CSP 26-003KB (BP022) – ADDENDUM No.01
Gym Renovations and Additions

Fort Bend Independent School District
2023 Bond Program

Addendum Number One (01)
TO PLANS AND SPECIFICATIONS FOR
CSP 26-003KB BP022 Gym Renovations
Fort Bend ISD
STANTEC Project Nos.: 214001246

October 10, 2025

A1 AD602 HGES

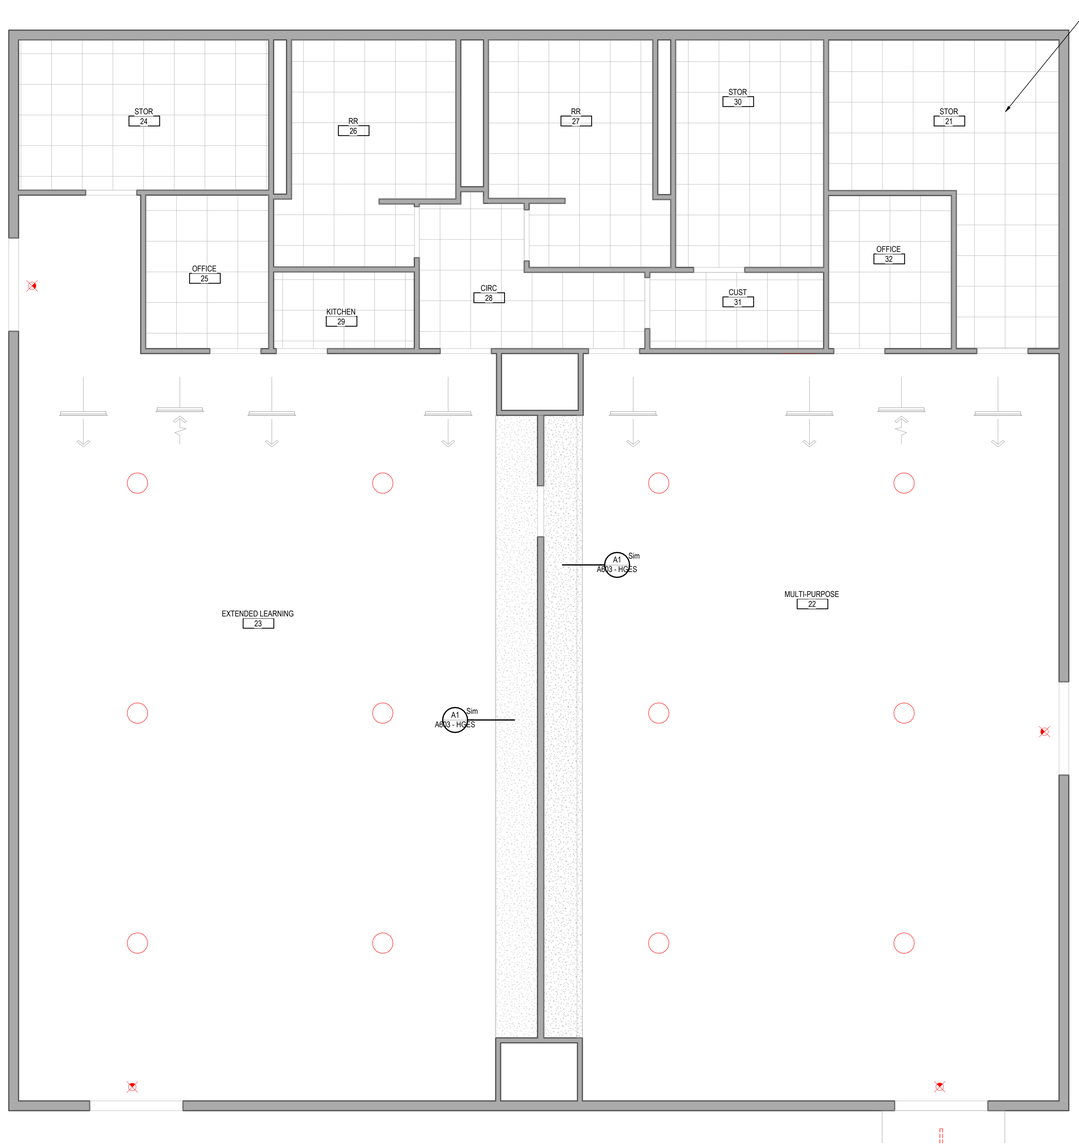
b. AD602 – HGES – ARCHITECTURAL DEMOLITION REFLECTED CEILING PLAN
- i. ADDED SHEET

1 ELECTRICAL POWER PLAN - LEVEL 1 - NEW GYM
Scale: 1/8" = 1'-0"

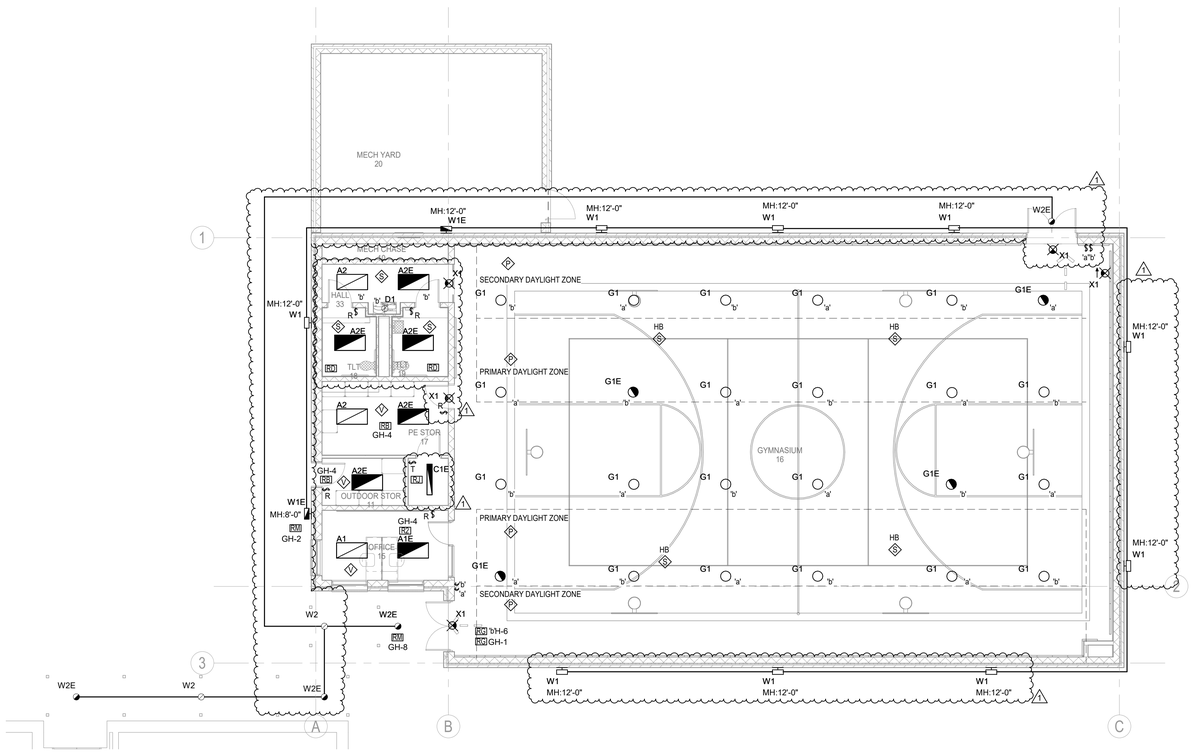
d. SHEET E201 HGES ELECTRICAL FLOOR PLANS
- i. SHOWED EXISTING EGRESS LIGHTING FOR COORDINATION.
- ii. REVISED ELEVATION OF EXTERIOR WALL PACKS.
- iii. REVISED LIGHTING TO MATCH ARCHITECTURAL LAYOUT.
- iv. CLARIFIED LOCATION OF GYMNASIUM RECEPTACLES.

1 **ELECTRICAL ONE-LINE DIAGRAM**
Scale: N.T.S.

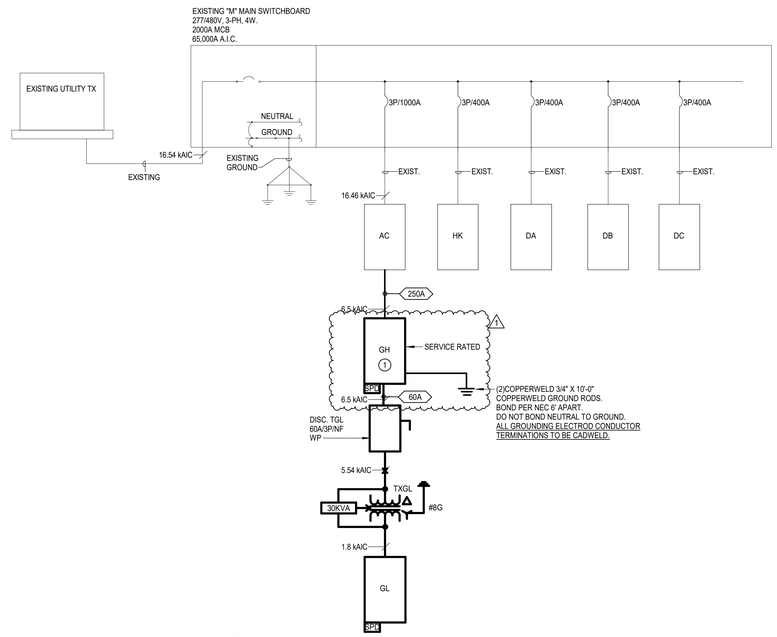
f. SHEET E401 HGES ELECTRICAL ONE-LINE AND PANEL SCHEDULES
- i. REVISED BREAKER SIZE AND CONDUCTORS FOR GH, SRTU-1 AND IEWH-2.

Project No.	Scale
214001246	3/32" = 1'-0"
Revision	Drawing No.
1	S201.1-PES

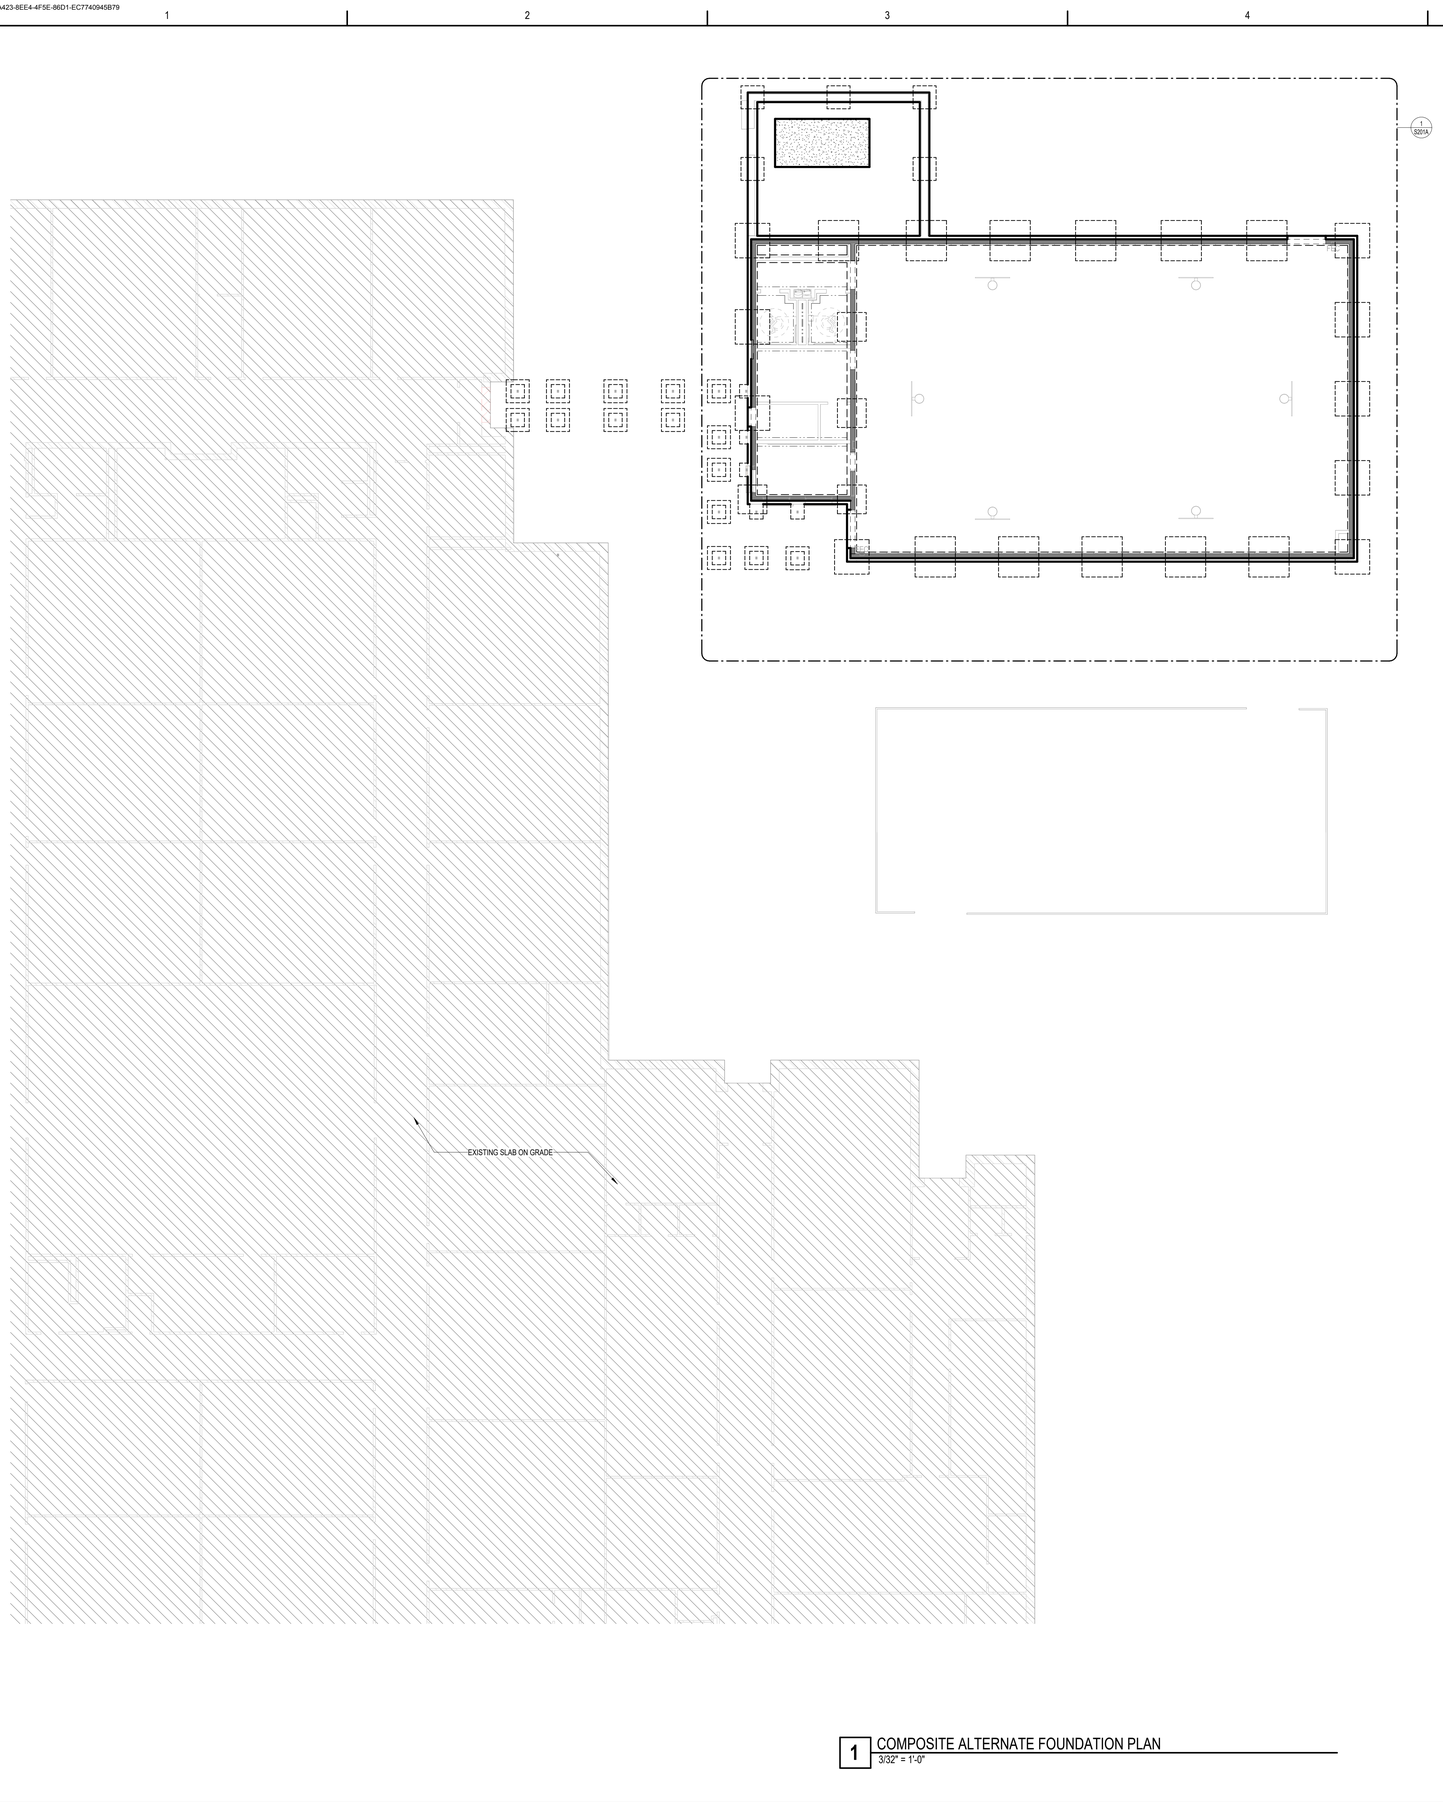
d. **S201.1-PES-FOUNDATION PLAN ALTERNATE 3A**
   i. SHEET S201.1 WAS ADDED TO THE SET.
e. **S201A-PES-FOUNDATION PLAN-GYMNASIUM**
   i. BUILDING DIMENSIONS WERE MODIFIED.
   ii. SLAB THICKENINGS WERE REMOVED FROM PLAN, SINCE CMU WALL WAS CHANGED TO A CFMF WALL.
   iii. DETAIL 6/S402 (SIM) WAS ADDED TO PLAN.
   iv. PAVEMENT NOTE WAS ADDED TO PLAN.

Project No.	Scale
214001246	1/4" = 1'-0"
Revision	Drawing No.
1	A113 - PES

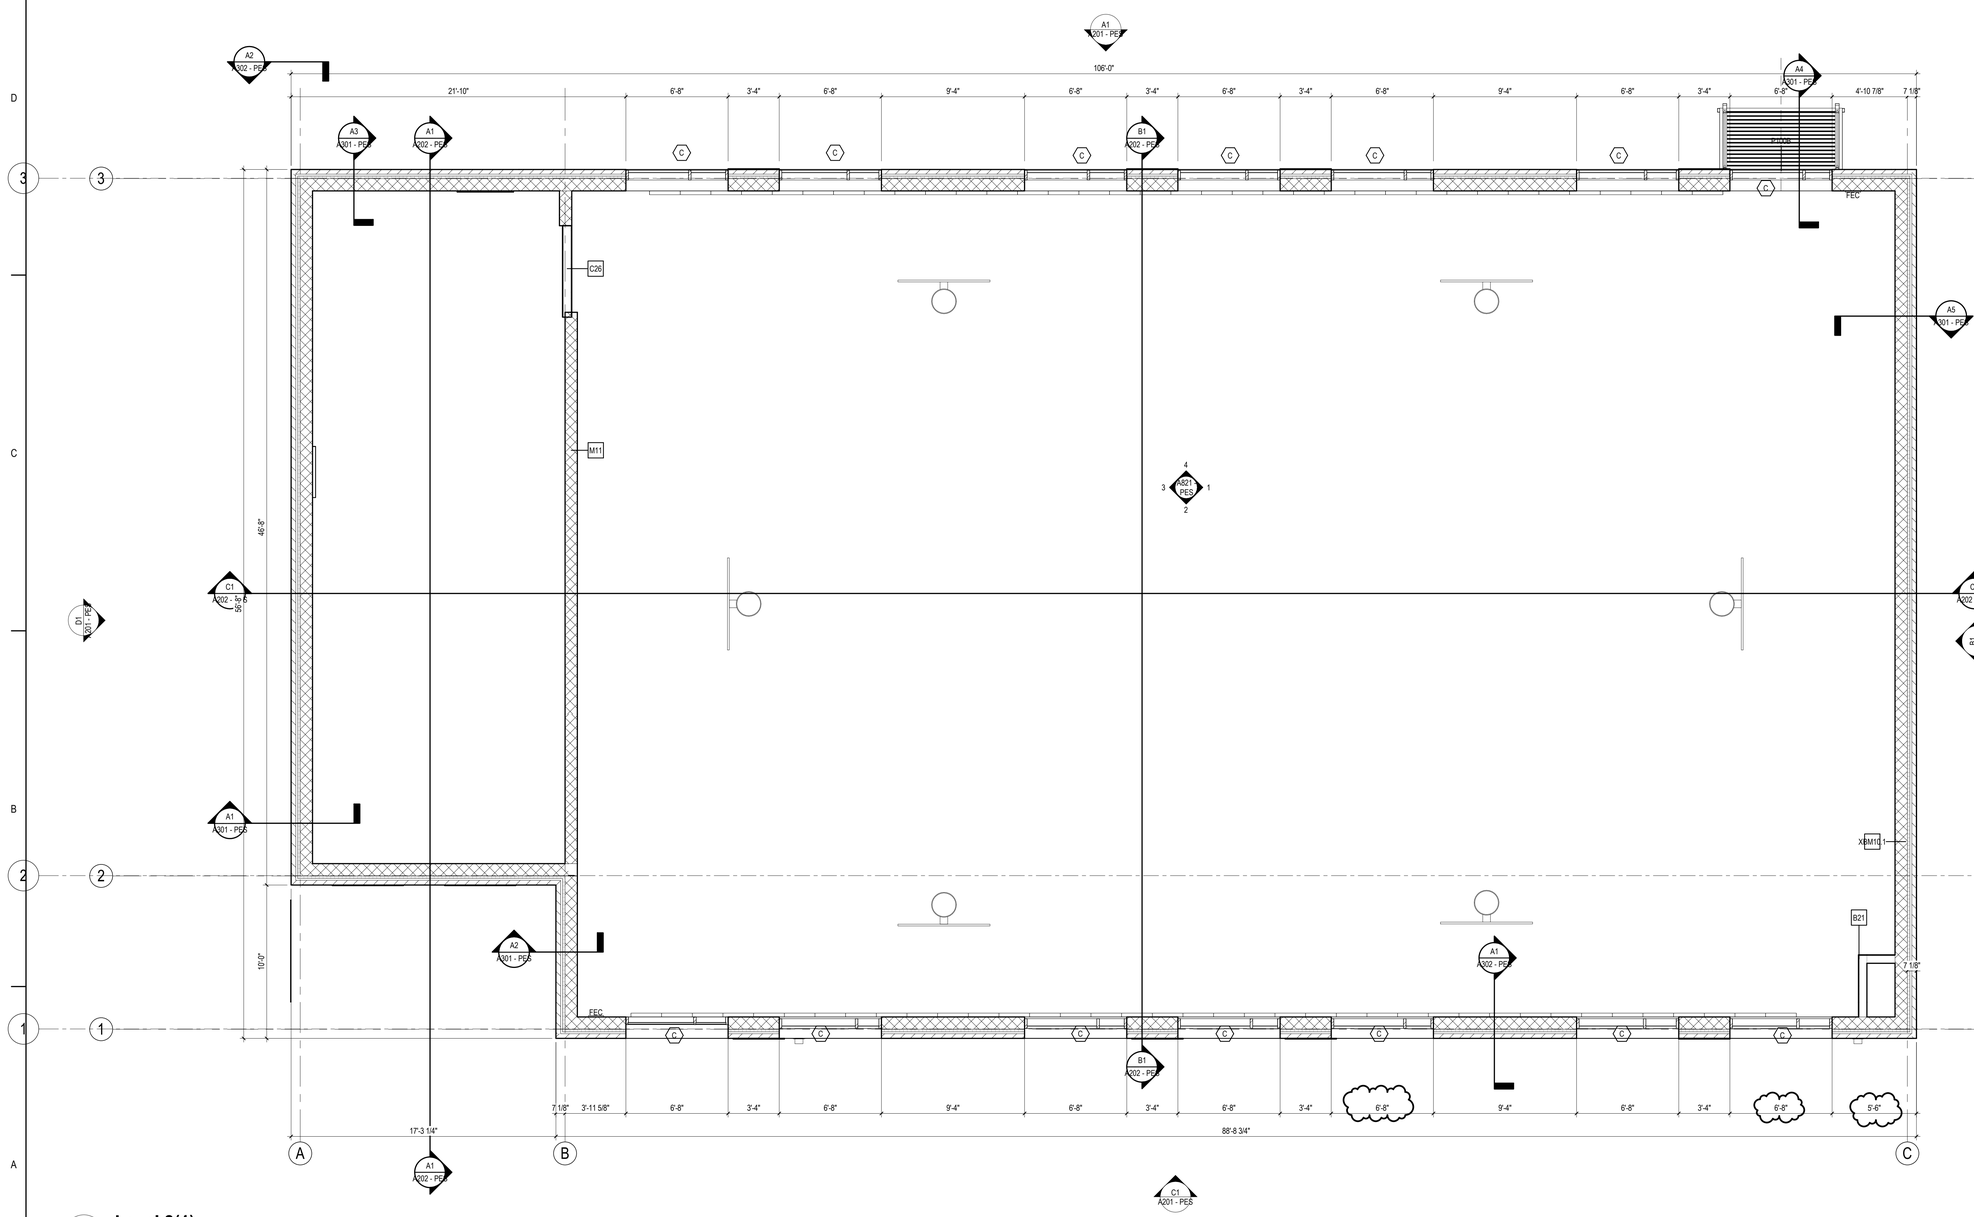
e. A113 – PES GYMNASIUM CLERESTORY PLAN
i. REVISED TWO WINDOWS IN SOUTHEAST CORNER TO BE 6'8" IN DIMENSION

A1 A321 — **DETAIL @ BRICK LEDGE**
1 1/2" = 1'-0"
PES

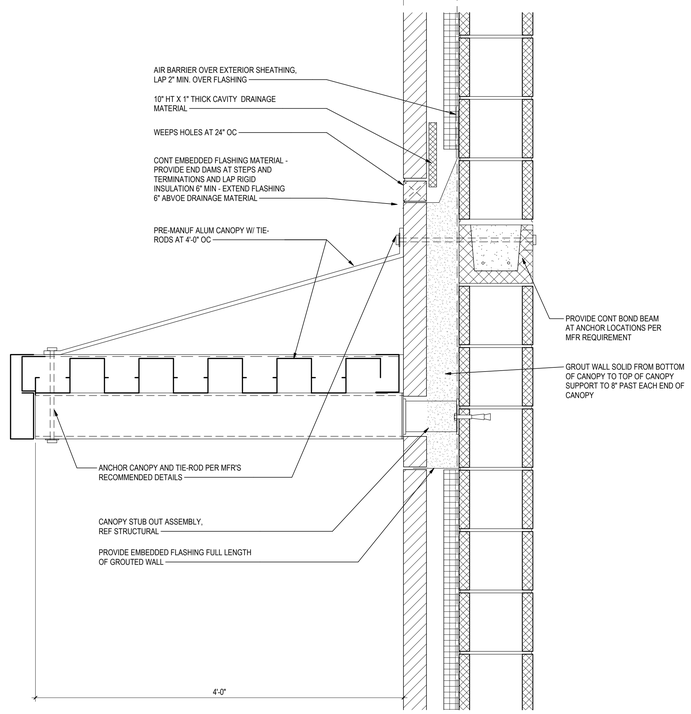
k. A321 – PES – EXTERIOR WALL SECTION DETAILS
i. CLARIFIED BRICK LEDGE DIMENSION ON DETAIL A1 AS 7 1/8"

Project No.	Scale
214001246	As indicated
Revision	Drawing No.
1	P201-PES

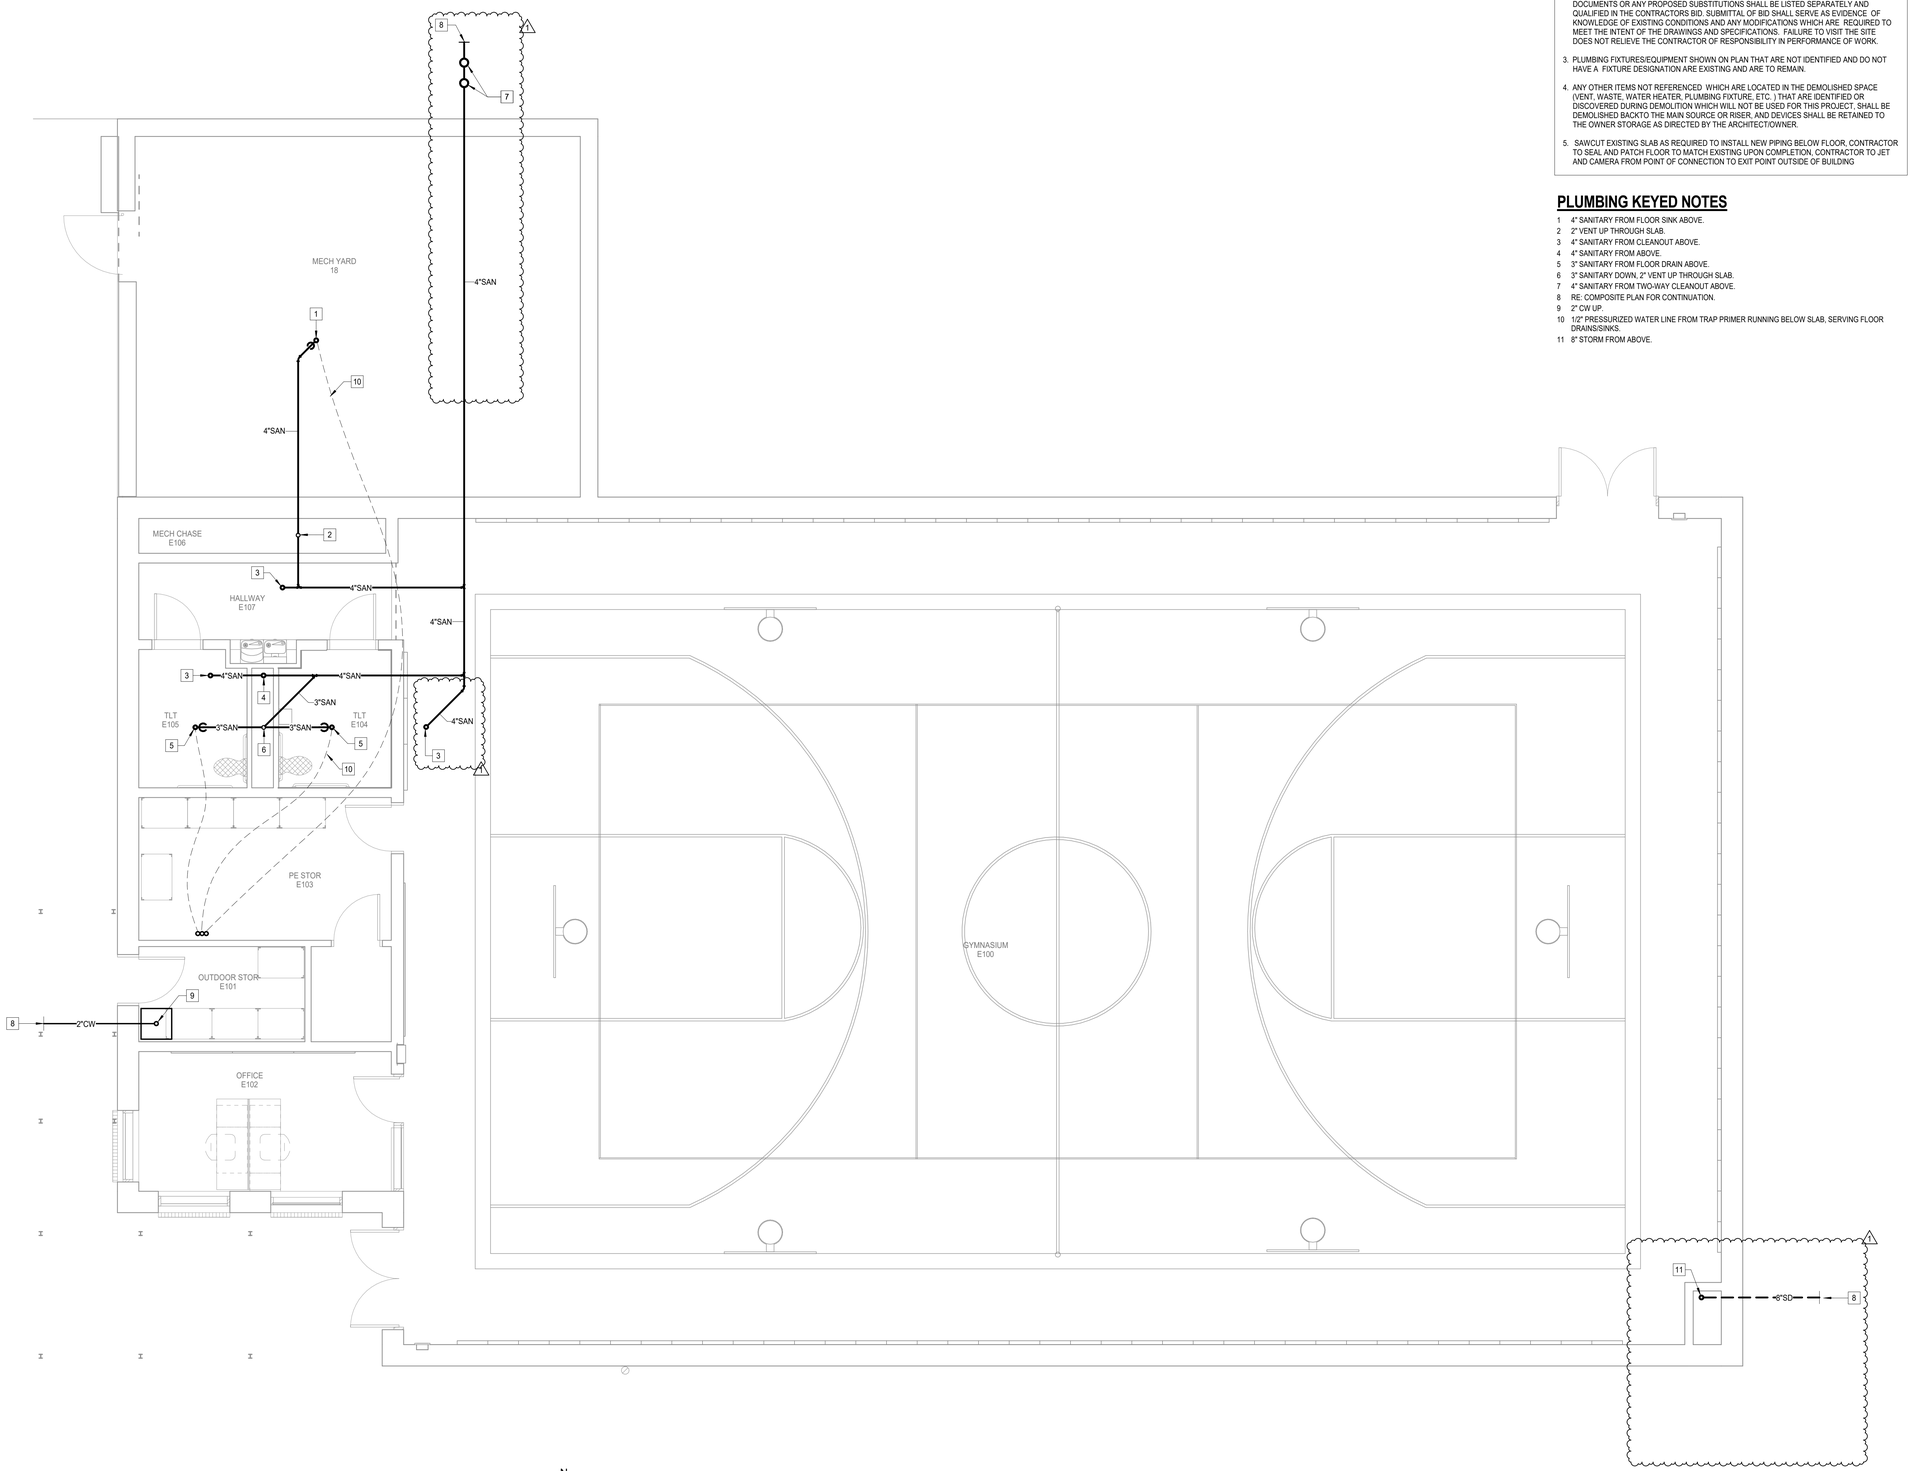
i. SHEET P201-PES PLUMBING UNDERFLOOR ENLARGED PLANS – NEW GYM
- i. REVISED SANITARY AND STORM POINT OF CONNECTION.
